**Standards of Performance for
Fossil-Fuel-Fired Steam Generating Units for Which
Construction Is Commenced After August 17, 1971
(40 CFR 60 subpart D)**

**Standards of Performance for
Electric Utility Steam Generating Units for Which
Construction Is Commenced After September 18, 1978
(40 CFR 60 subpart Da)**

**Response to Public Comments on
Rule Amendments Proposed May 3, 2011 (73 FR 33642)**

US Environmental Protection Agency
Office of Air Quality Planning and Standards
Sector Policies and Programs Division
Research Triangle Park, NC 27711

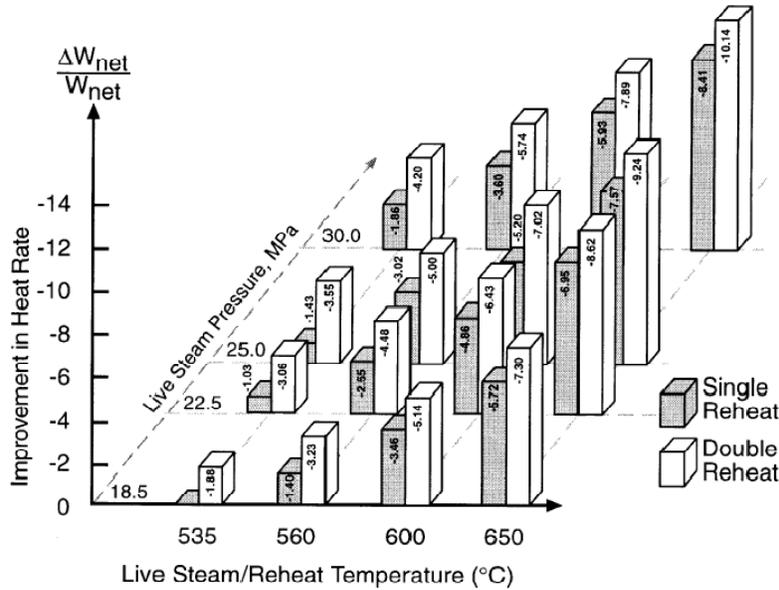
Comment: Several commenters (4712, 4765, 4768, 4836, 5075) state that the proposed NO_x emissions limit is not achievable on a nationwide basis, and the final rule should, therefore, be revised upwards to reflect the actual levels of performance achievable. In addition, a separate NO_x emissions limit should be set for modified EGUs subject to the NSPS. Several commenters (4712, 4768) state that the methodology EPA used to select the proposed NO_x emissions limit value does not sufficiently address variability in EGU fuel use, equipment design, and operation. One commenter (4768) includes their analysis of the data on which EPA based its determination that the proposed NO_x emissions limit is achievable using BSER. Based on this analysis, the commenter asserts that an appropriate NO_x emissions limit is 0.83 lb/MWh for new units and 1.1 lb/MWh for modified or reconstructed units. The commenter states that the NO_x emissions standard for modified units should be based on the performance of cell burners, wet-bottom boilers, and cyclone fired EGUs. The commenter further notes that recent consent decrees for SCR-equipped cyclone boilers require NO_x emissions between 0.100 to 0.120 lb/MMBtu.

Response: The available data demonstrates that the proposed standard of 0.70 lb/MWh is achievable by both new and retrofit pulverized coal and fluidized bed boilers burning various coal types. This is true for modified units as well as new and reconstructed units; however, in recognition of the difficulties of retrofitting certain modified facilities with advanced combustion controls, the final NO_x standard for modified facilities is 1.1 lb/MWh. Since the CEMS data used in establishing the standards included long term data, various operating conditions and variability are inherently accounted for. I The comment about cell burners and wet-bottom boilers is unclear. The Cardinal 1, 2, and 3, Muskingum River 5, and Belews Creek 1 EGUs are cell burners retrofit with SCR and have demonstrated emission rates below 0.70 lb/MWh. In addition, the Dallman 4 EGU is a wet-bottom boiler with SCR operating below 0.70 lb/MWh. Cyclone boilers are the only EGU design that has not been demonstrated to be able to achieve the proposed standard. Subbituminous cyclone-fired EGUs (Coffeen, Baldwin, and Allen S. King) have demonstrated NO_x emission rates of less than 0.95 lb/MWh are achievable. However, no bituminous or lignite-fired cyclone EGUs have achieved comparable emission rates. The best performing bituminous and lignite-fired cyclone EGUs without SCR are the Merrimack and Leland Olds facilities. These EGUs have demonstrated that cyclone EGUs can maintain NO_x emission rates to less than 4.0 lb/MWh. The addition of 75% efficient SCR (or a multi-pollutant control technology) to these facilities would reduce NO_x emissions to less than 1.1 lb/MWh.

The differences in the calculated 30-day emission rates between the commenter and the EPA is attributed to the procedure used to calculate the 30-day averages. The EPA 30-day averages are calculated using the procedures described in the proposal (sum of emissions of the applicable pollutant divided by the sum of the gross output), while the commenter used the average of the hourly emission rates for the 30-day period. As stated in the

proposal, the EPA procedure results in lower numerical emission rates because hours with high emission rates but low heat inputs (typical of startup, shutdown, and low load operation) are not weighted as heavily.
